Vogtle
units 3&4 Nuclear Development

Vogtle Units 3&4 Nuclear Island Basemat Design Increase to Specified Compressive Strength of Concrete

July 19, 2012

Vogtle Basemat Design

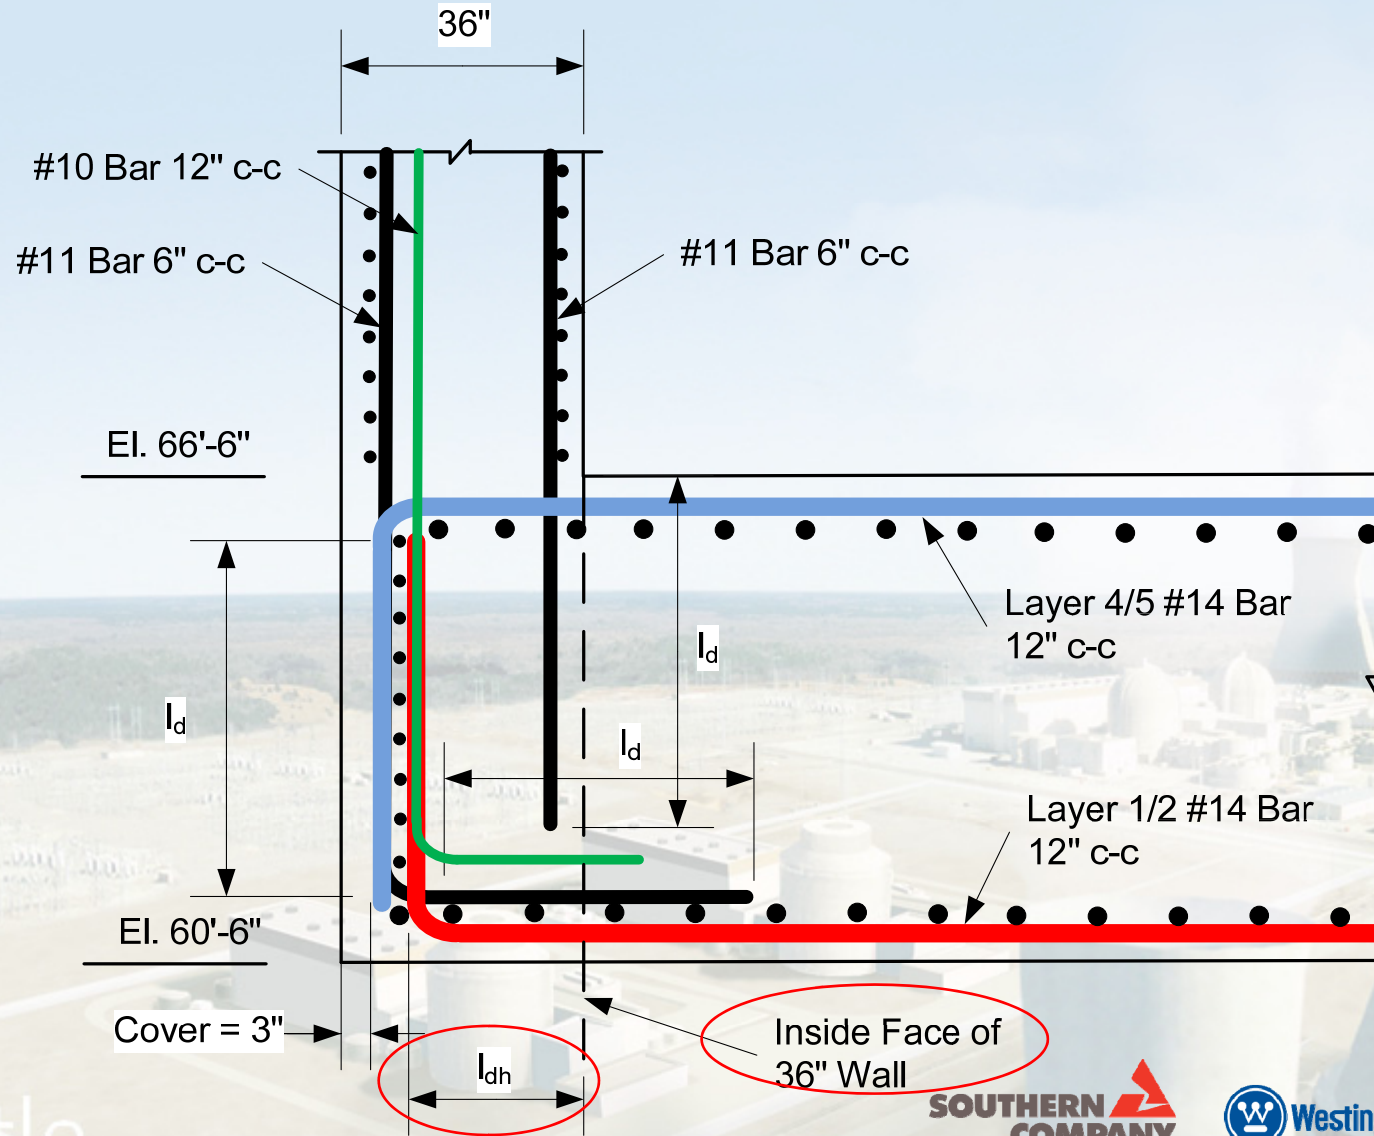
- The basemat perimeter detail is illustrated in UFSAR Figure 3H.5-3
- The required standard hook development length of Layer 1 and 2 rebar is 32.1" for 4000 psi concrete
- The available Layer 1 and 2 standard hook development length is 29.5" due to rebar placement constraints caused by the MSE wall

- The required standard hook development length l_{dh} is specified in ACI 349-01 12.5.2
 - The two variables are the nominal rebar diameter and the specified compressive strength of concrete
 - Changing the specified compressive strength of concrete reduces the required development length for a given bar diameter
- The solution is to increase the specified concrete compressive strength of the basemat concrete from 4000 psi to 5000 psi
- The required l_{dh} for Layers 1 and 2 will then be developed within the inside face of the 36" wall

Figure 3H.5-3

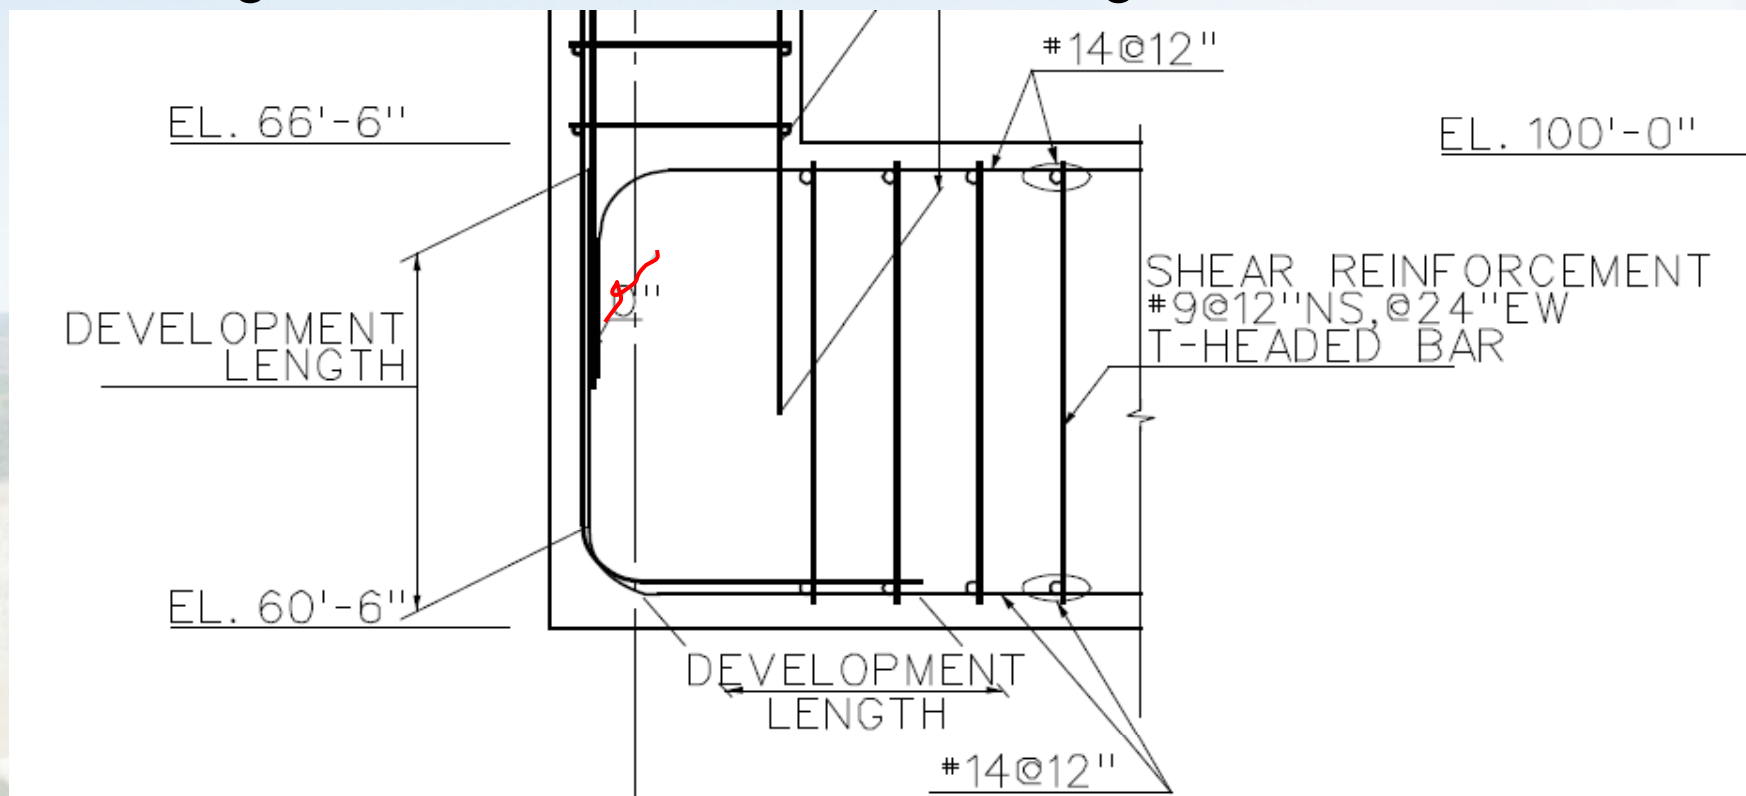
- FSAR 3.8.4.6.1.1 - Add 5000 psi concrete for basemat

- [*The compressive strength of concrete used in the seismic Category I structures and containment internal structures is $f'_c = 4000$ psi. For the nuclear island basemat the compressive strength of concrete is $f'_c = 5000$ psi. For the SC composite portion of the shield building structure including the connection region below the SC/RC interface and the shield building roof, the compressive strength of concrete is $f'_c = 6000$ psi.]* The test age of concrete containing pozzolan is 56 days. The test age of concrete without pozzolan is the normal 28 days. Concrete is batched and placed according to Reference 6, Reference 7, and ACI-349.*

- With the use of 5000 psi concrete the reinforcement design is in conformance with Figure 3H.5-3

Sensitivity study of 5000 psi concrete basemat

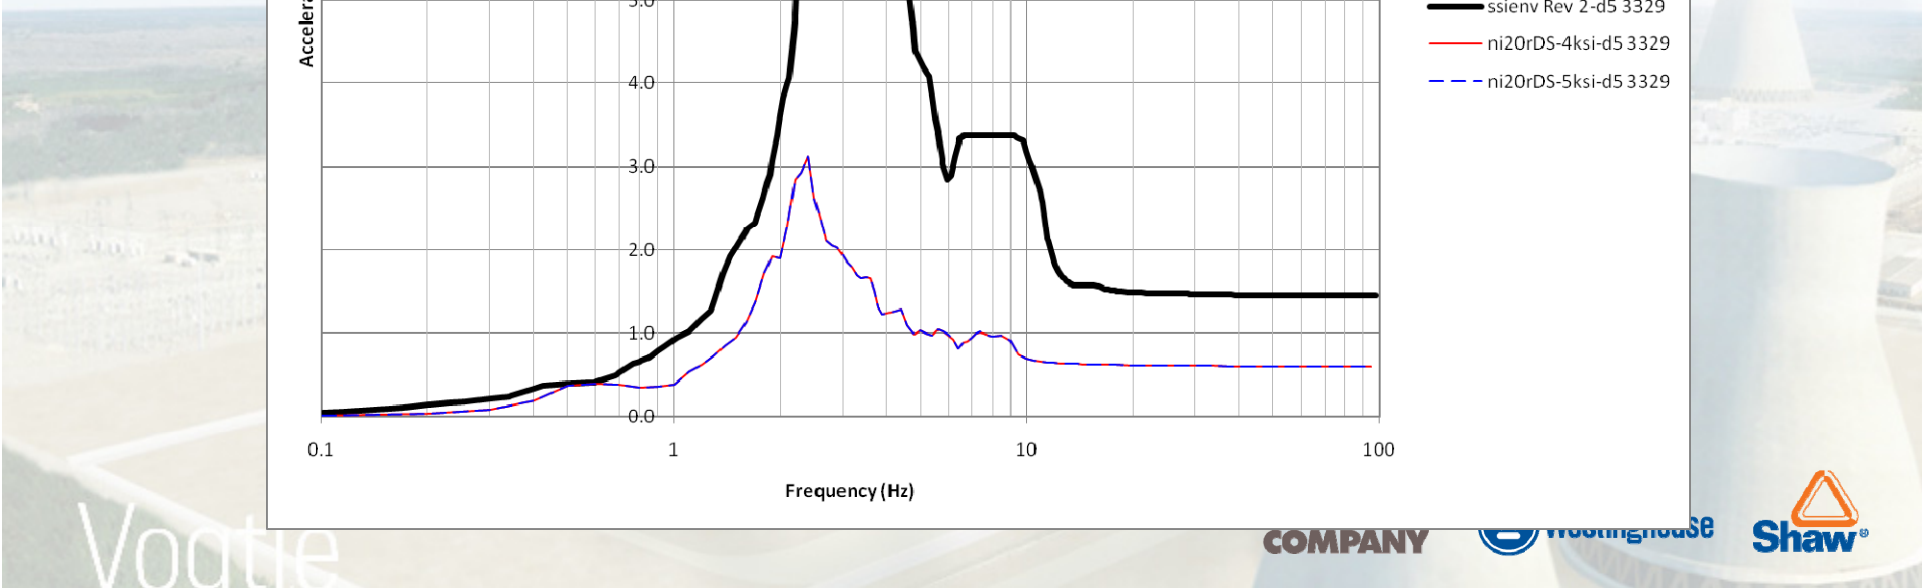
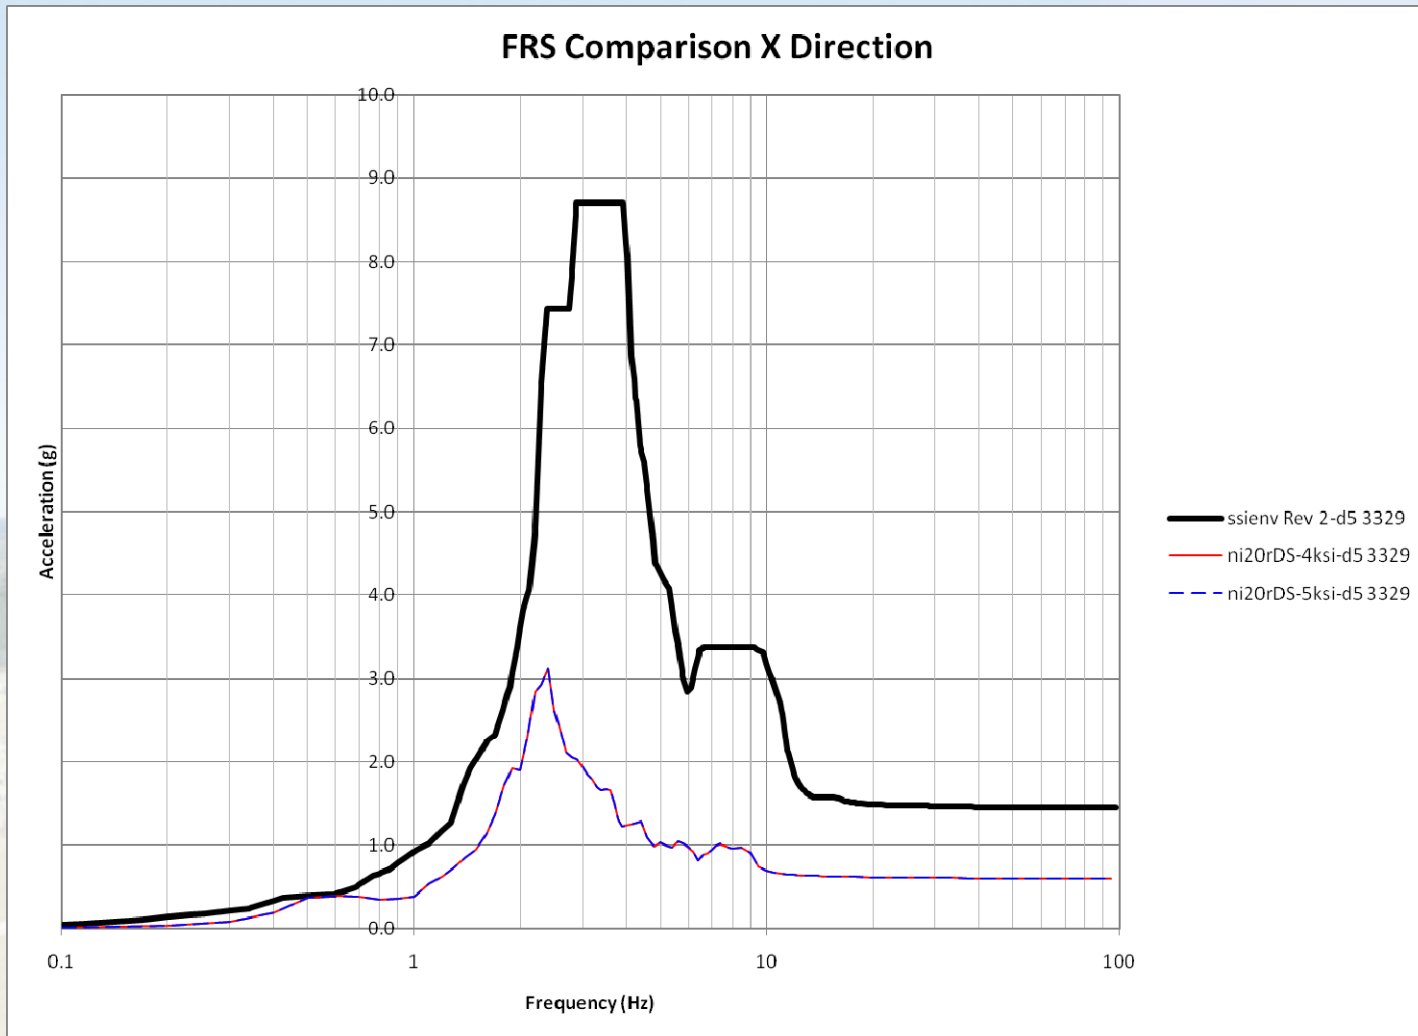
- A sensitivity study was performed using both 4000 psi and 5000 psi concrete for the basemat in a soil-structure interaction analysis.
- The SASSI ni20 model was modified by changing the modulus of elasticity of the basemat shell elements to reflect the 5000 psi concrete, including Vogtle best estimate soil profile and seismic input.
- The Floor Response spectra for all six key locations was compared. There was no change in FRS. There was no change in the maximum accelerations.
- Since there are no instances where the generic maximum accelerations are exceeded, there is no effect on the generic analyses
- Since there is no change in the maximum accelerations, there is no effect on the seismic design margins.

Comparison of SASSI basemat stresses

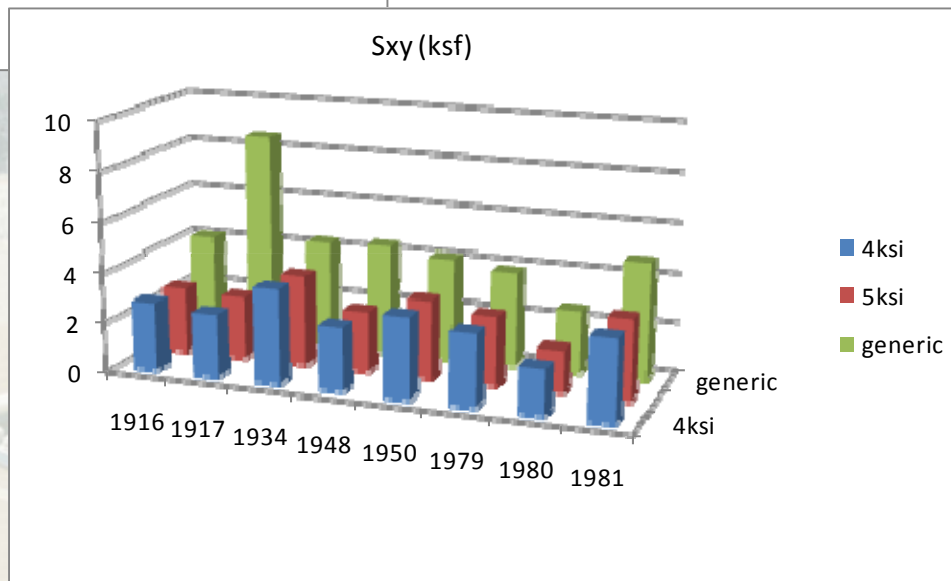
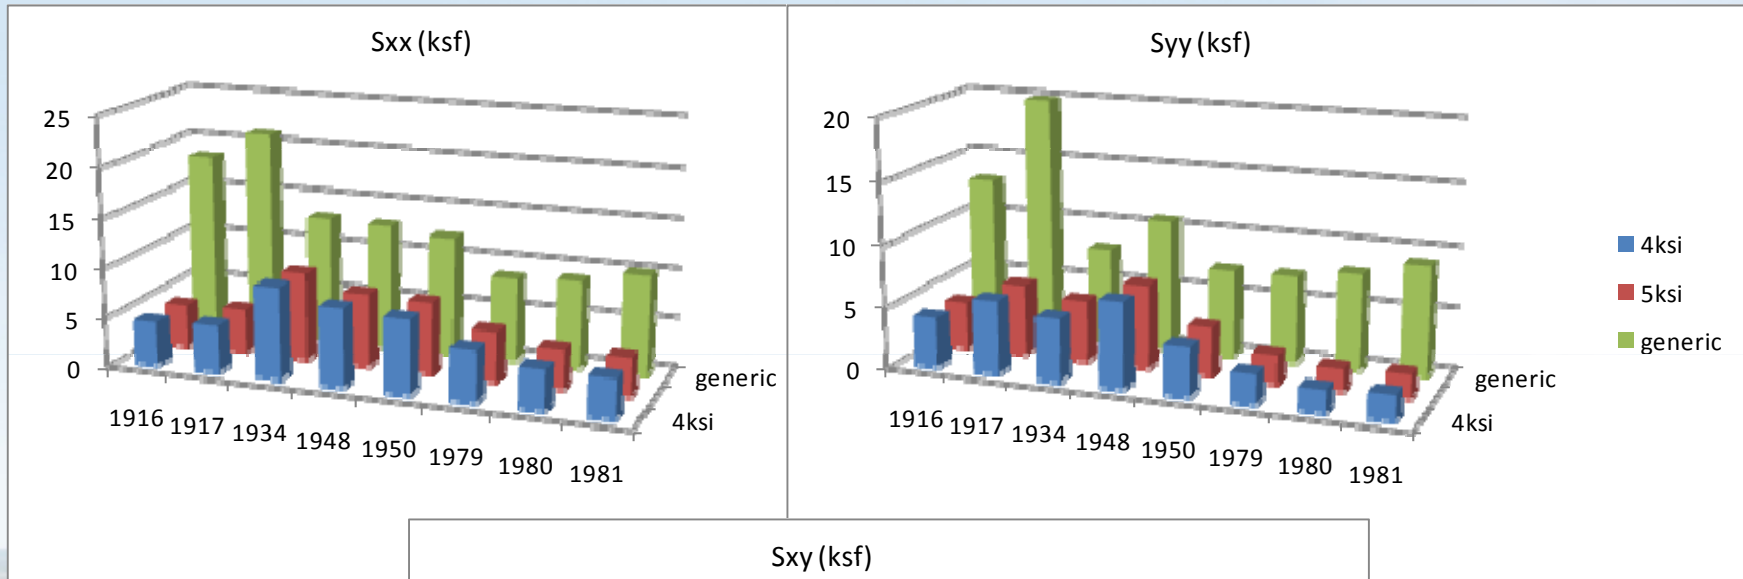
Similar Stresses for 4ksi and 5ksi basemat. Both are bounded by the generic envelope of all soil cases.
